TIS Service Bulletin Page 1 of 2

DELIVERY STOP & RECALL 18V-XXX: FUEL LEVEL SENSOR

This Service Information bulletin replaces SI B16 07 18 dated July 2018

F90 (M5)

Proper placement of cable tie (fuel pump removed for clarity) Correctly installed cable tie Incorrectly installed cable tie

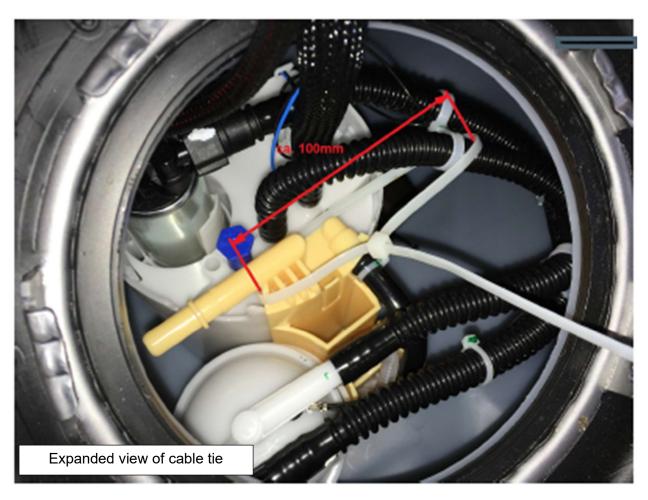
The distance between a fuel line on the fuel delivery unit (in-tank fuel pump) and the fuel level sensor is too short. The line could come into contact with the fuel level sending unit linkage. This could stop the linkage from travelling to the empty position on the sender.

Install a cable tie to the in-tank fuel line to prevent the fuel line from coming in contact with the fuel level sending unit linkage.

- Install cable tie (1) (PN 61 13 1 382 243) as shown in picture between corrugated hose and pump bracket.
- The cable tie has to be tightened to a distance of 100mm.
- Cut the cable tie end to size
- Check if fuel sending level unit linkage swings free
